Platform A1 - Booth area
Previous comments are
still valid, see following
slides

Platform A1 - Booth area

Important: the 12 columns of the Spray Booth have been modified after change of the Scrubber technology by Renault-VAZ

Axes 5-6/014-015

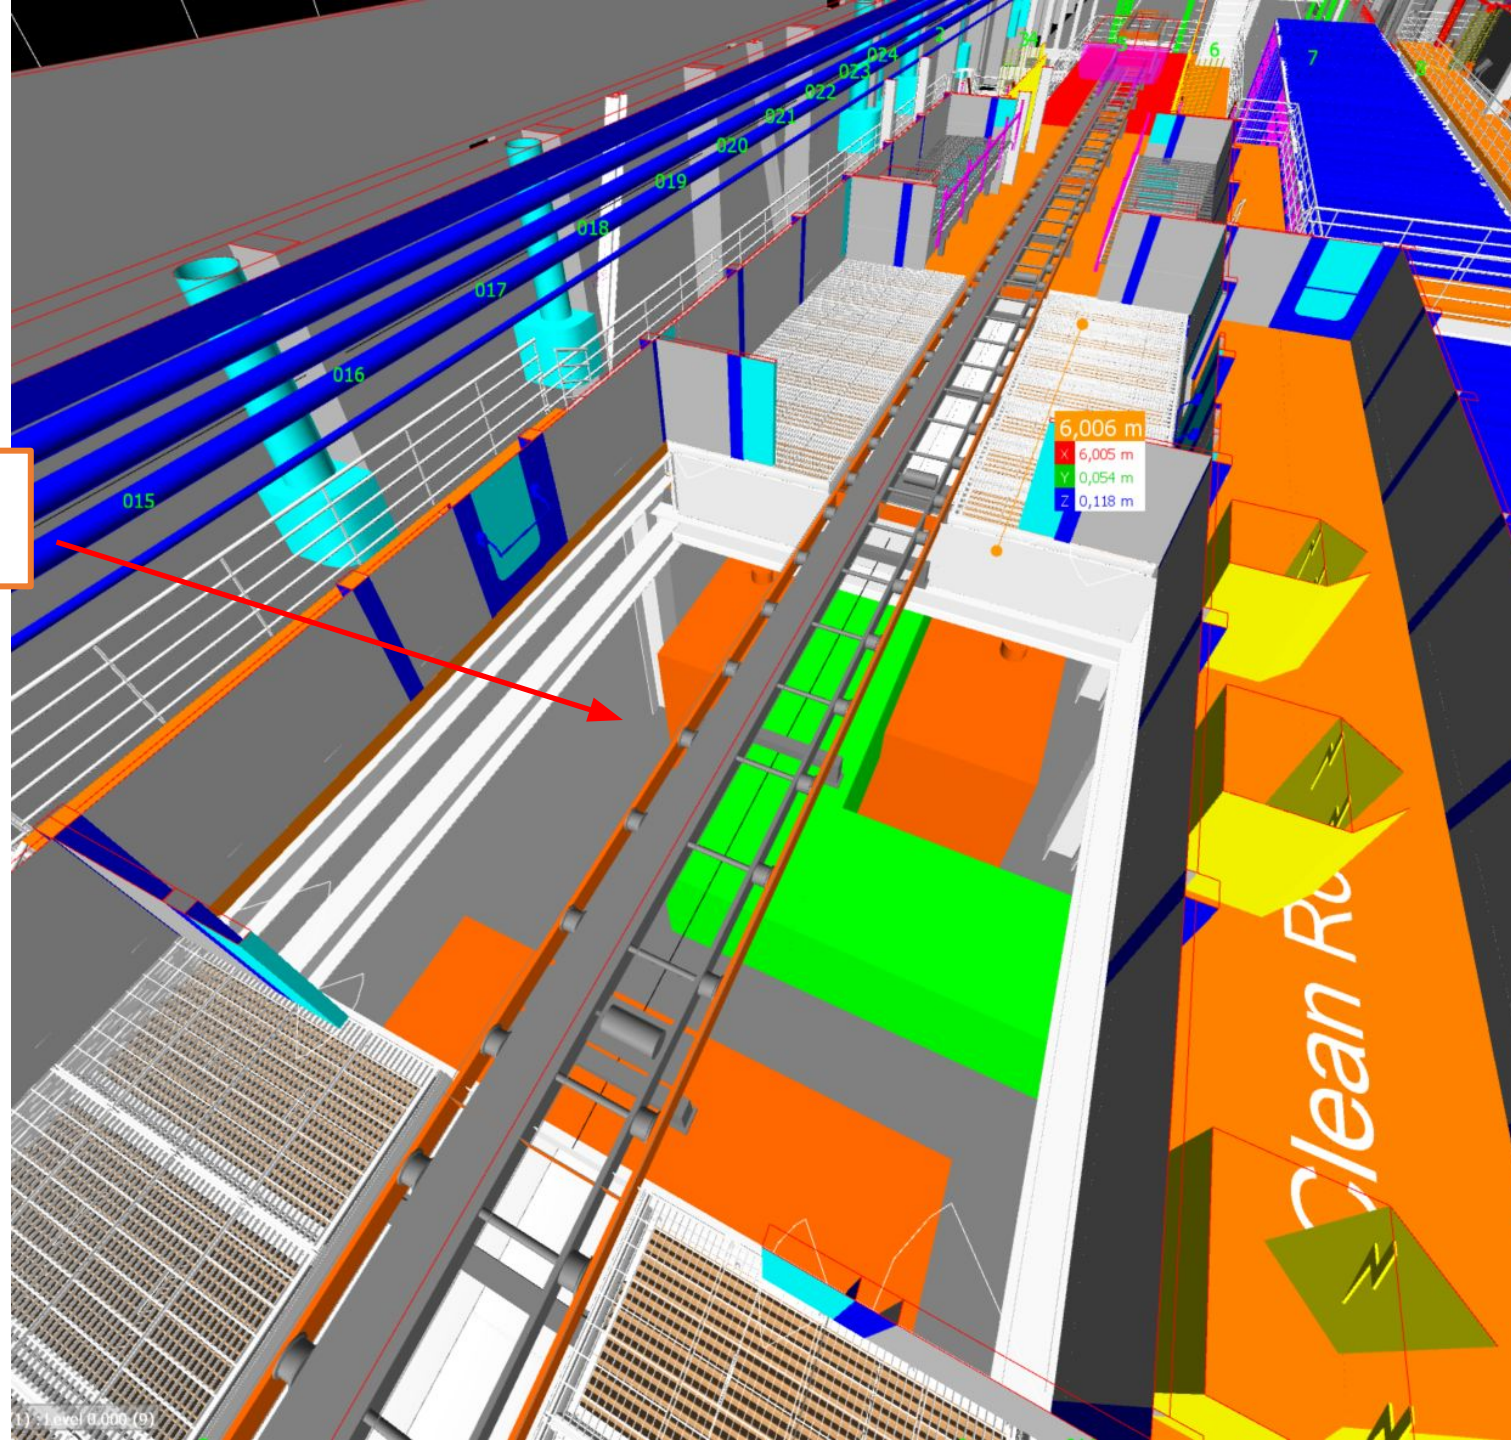
You forget the metal
sheet and Omega Beam

Full metal sheet plate
(t=5mm)

As you will see from our Booth layout & sections, the omega's purpose is to place the conveyor roller-bed;
Please check correct dimensions and elevation of the Omega steel profile in section H on drawing E540350033_D10_A

Axes 5-6/014-015

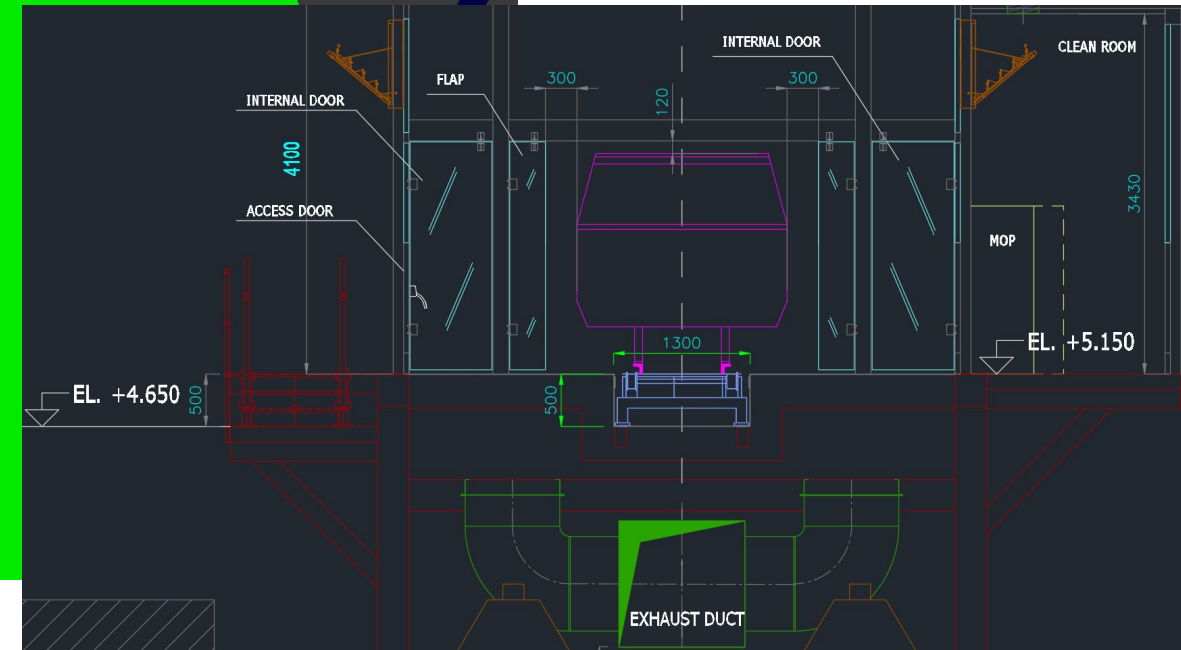
Side full metal sheet plate (non structural)
only for gaps flashing
(t=2÷3mm)

In Base coat and Clear coat zones we have lowered beams because we'll need to locate the **Drypan scrubber** (basically a big duct with filters) and the conveyor Roller-bed.

Axes 5-6/015-016

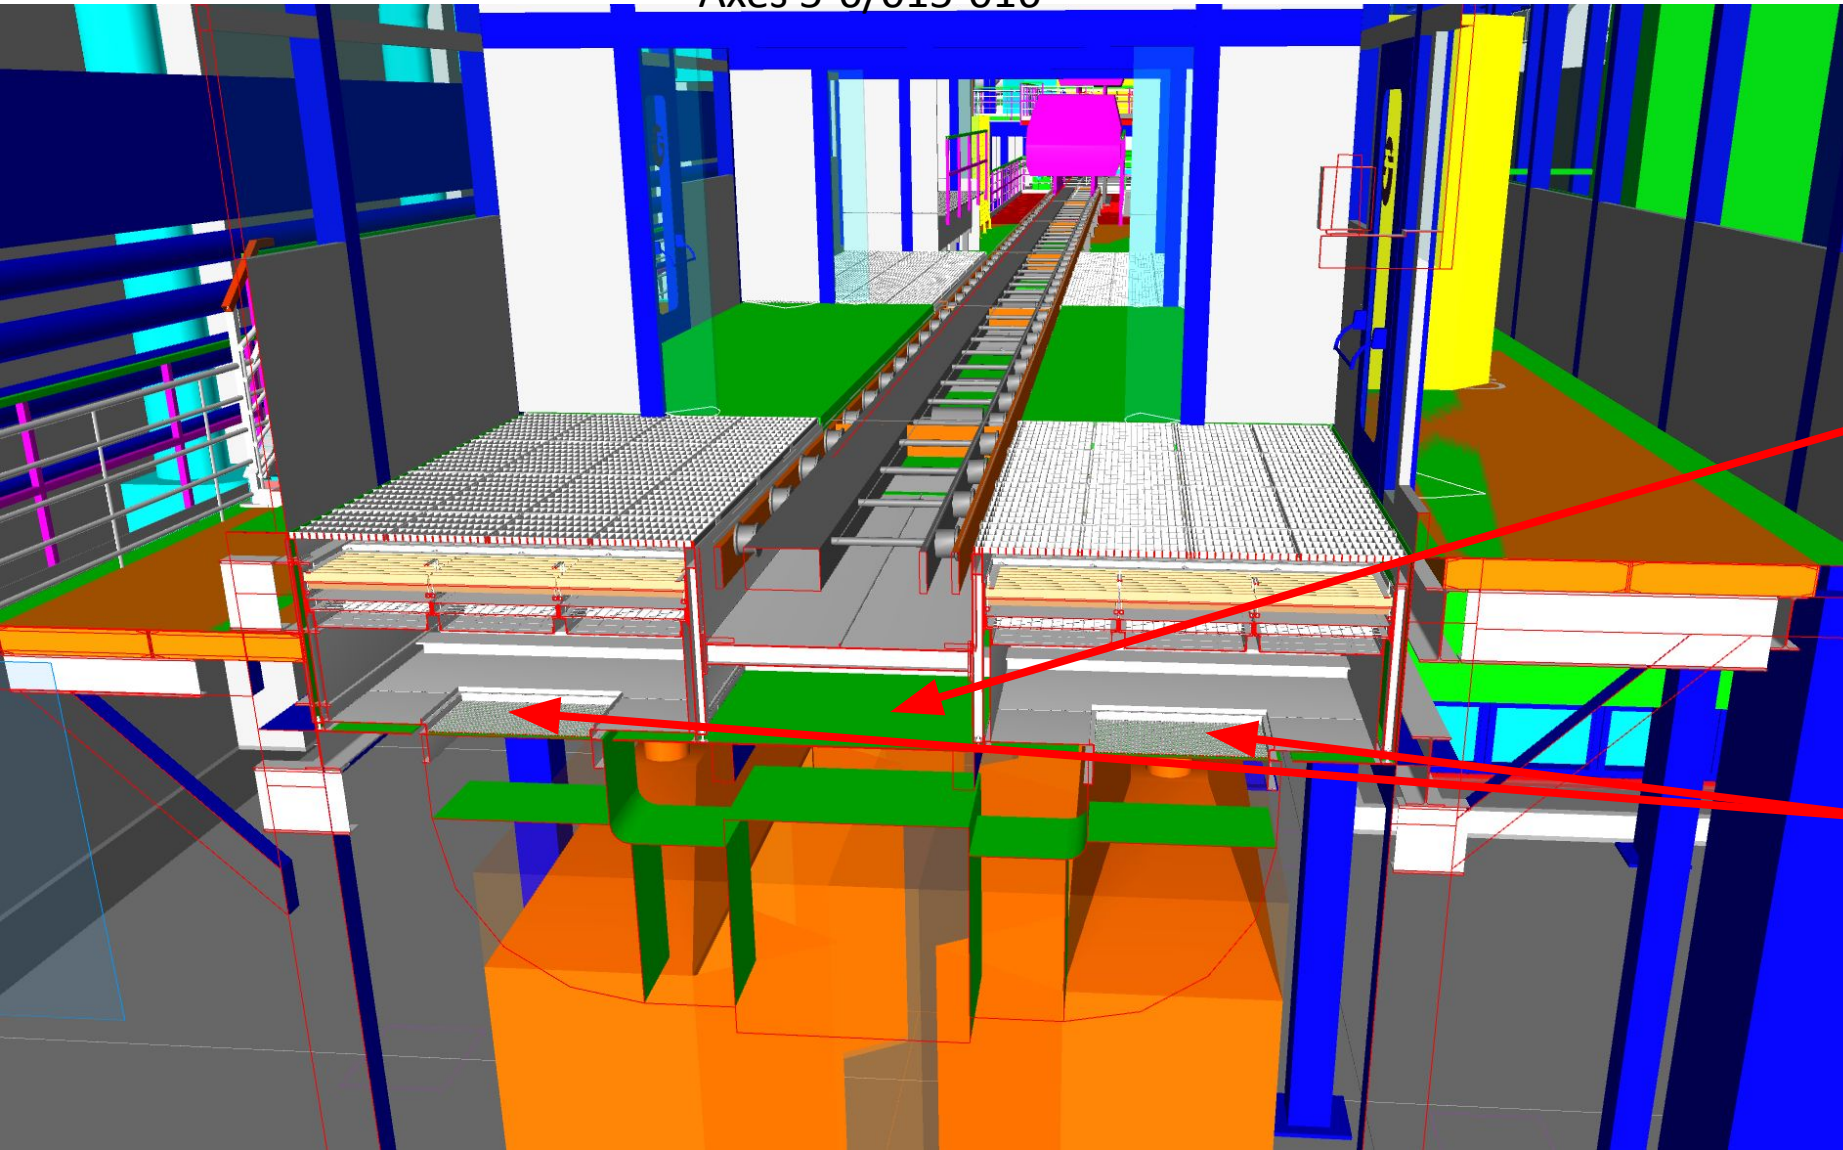
Please check our drawings (Booth layouts & sections, Drypan scrubber) for beams elevation;
Basically in these zones the TOP of the cross beams shall be at -505mm from level 4,65m = 4,145m

The bottom of this «tank» will have to be covered by full metal sheet plate (t=5mm)

Axes 7/013-014

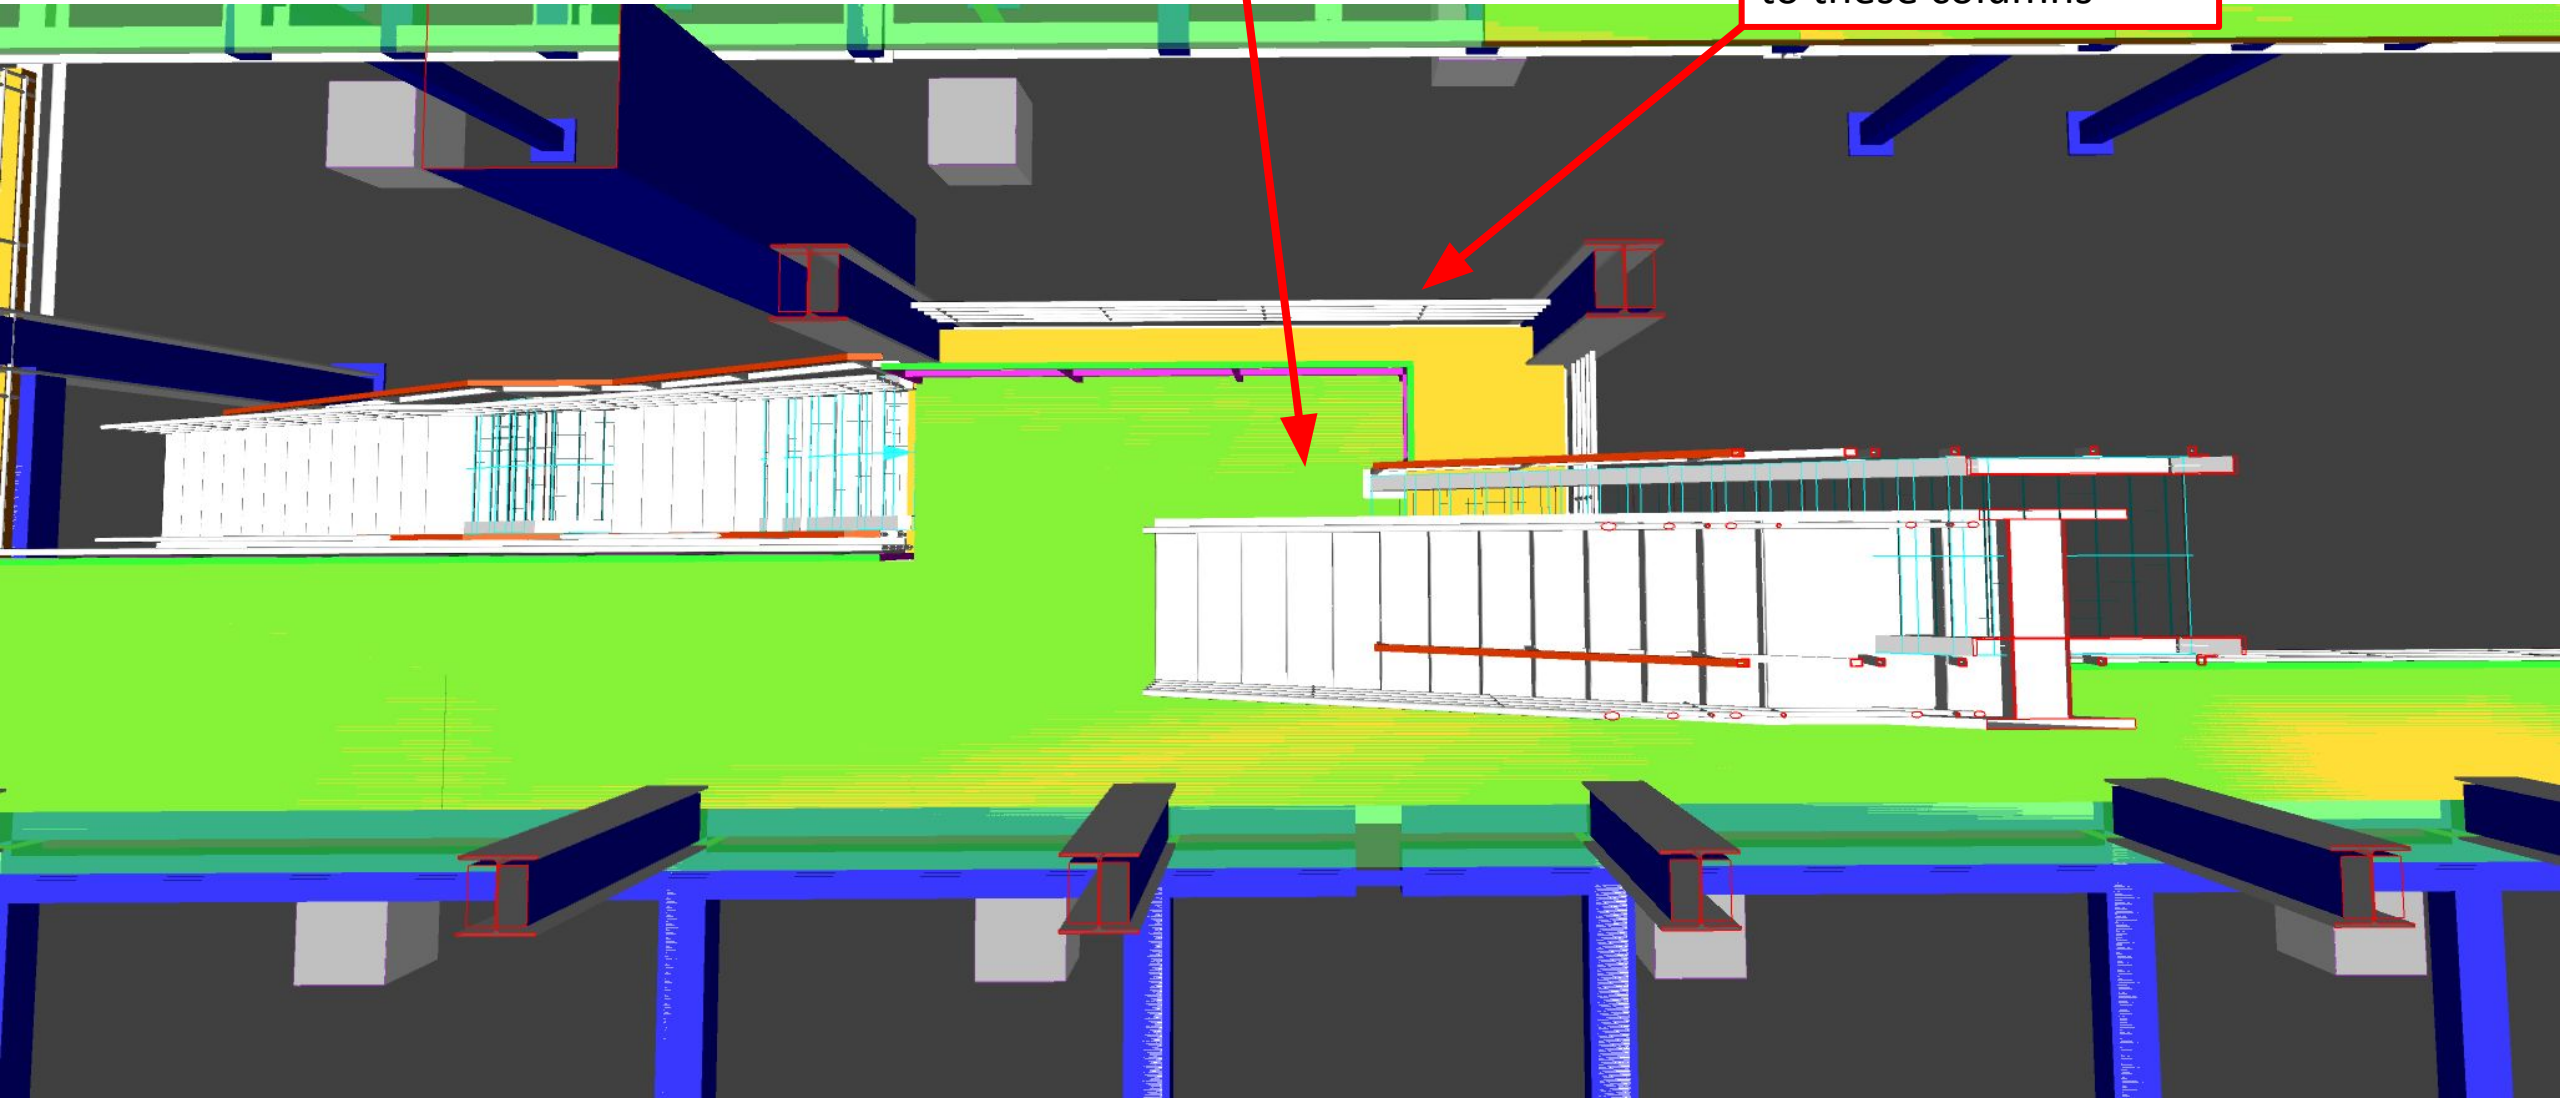
The tank floor will have to foresee two holes 950x950mm (one per side) for Extraction ducts, see layouts for location

In this zone the stair that goes on 9,80m level is not aligned to ours

OK to extend platform to these columns

Axes 5/012

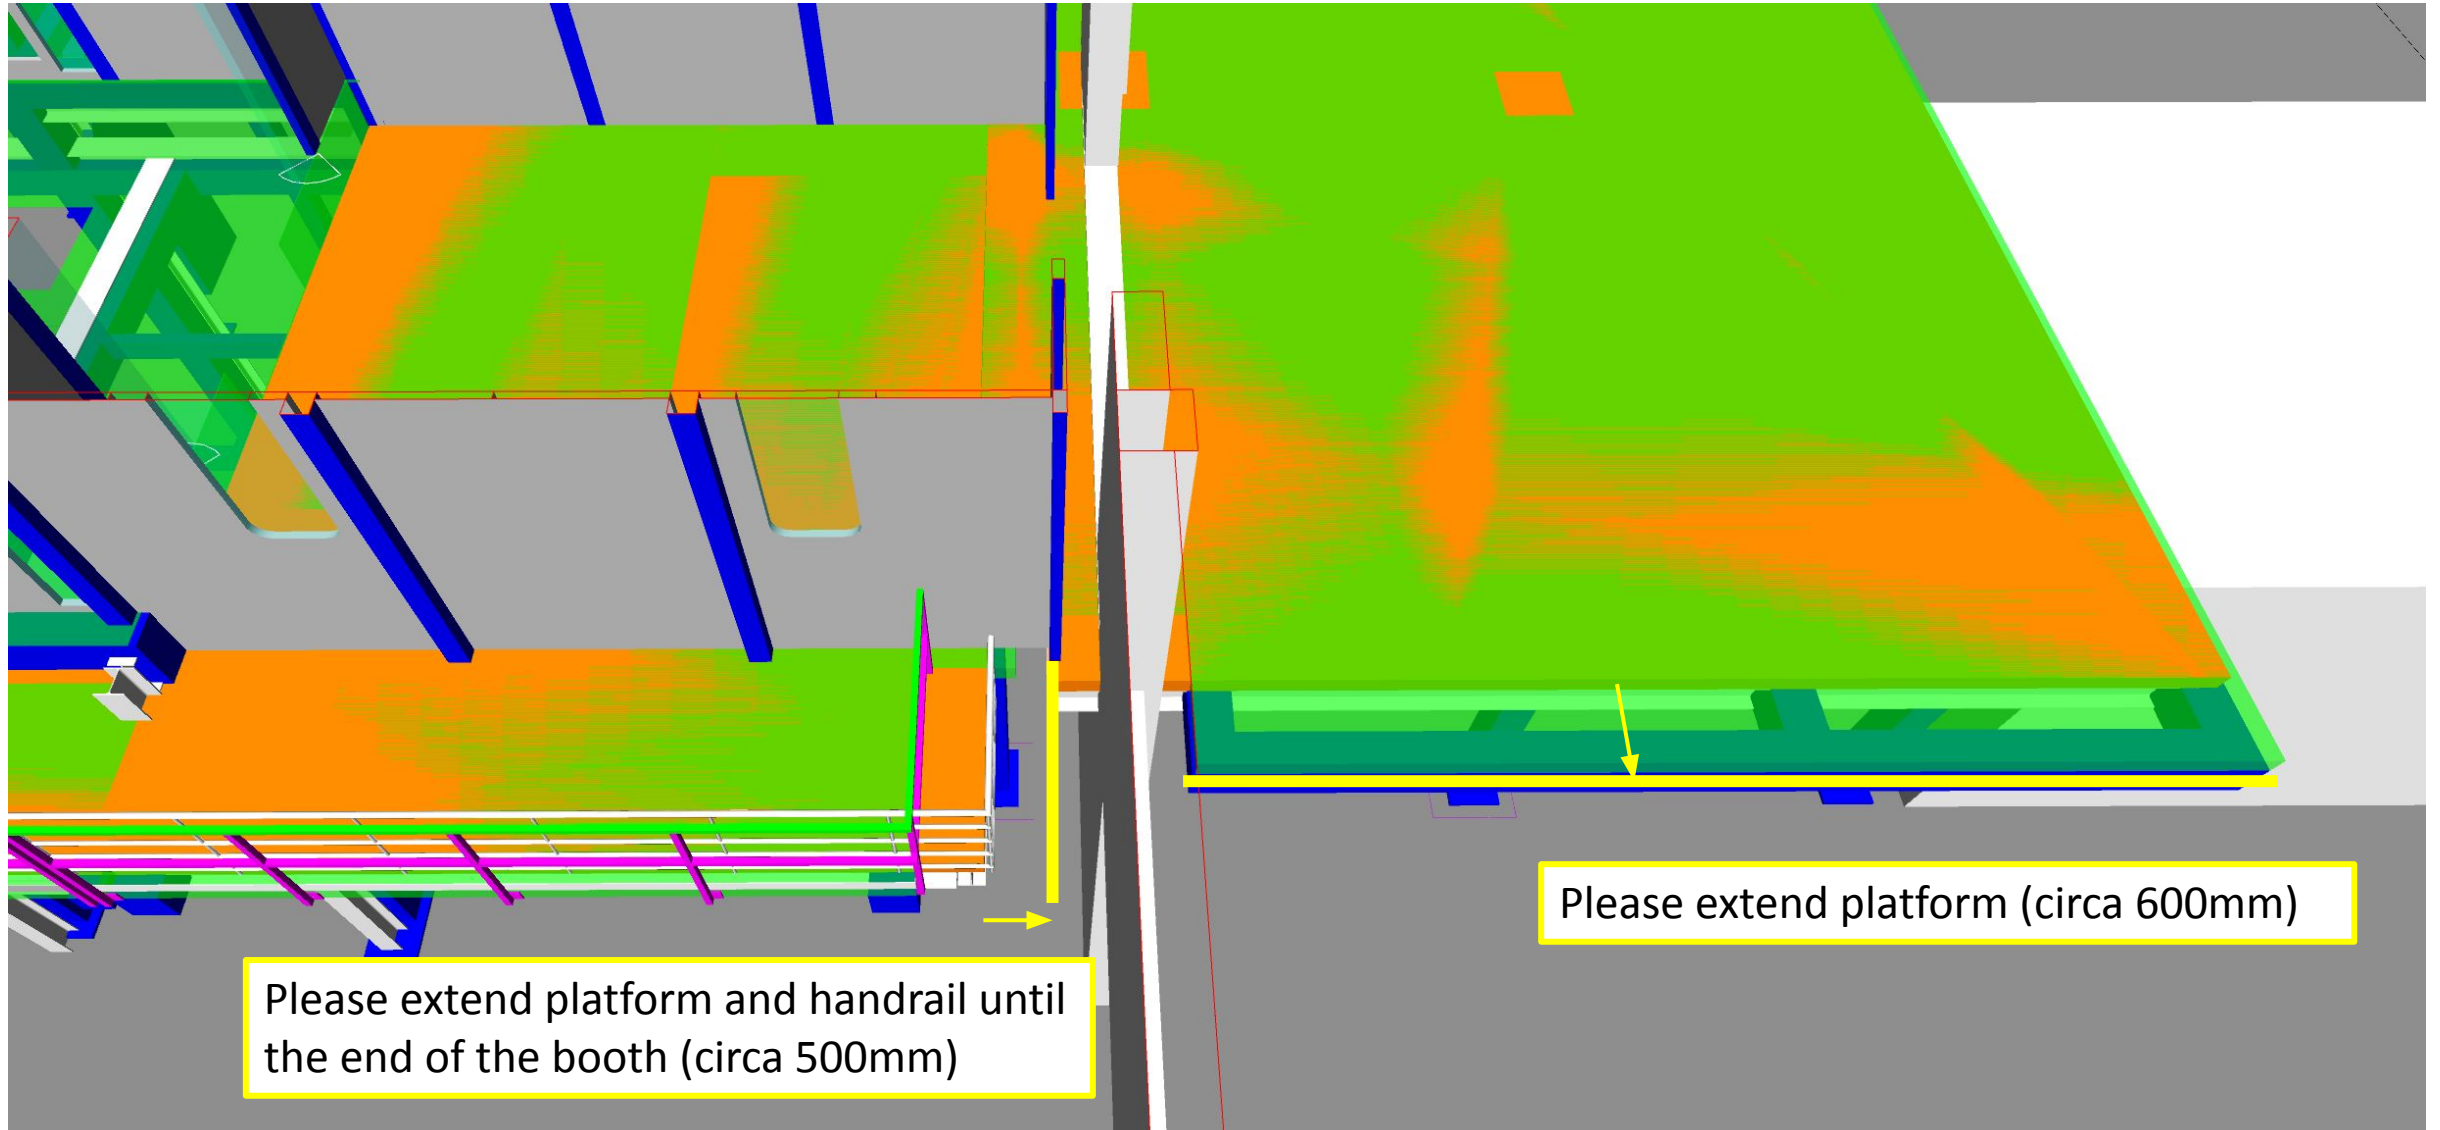
Be sure to respect Oven perimeter when modeling walkable modules around it
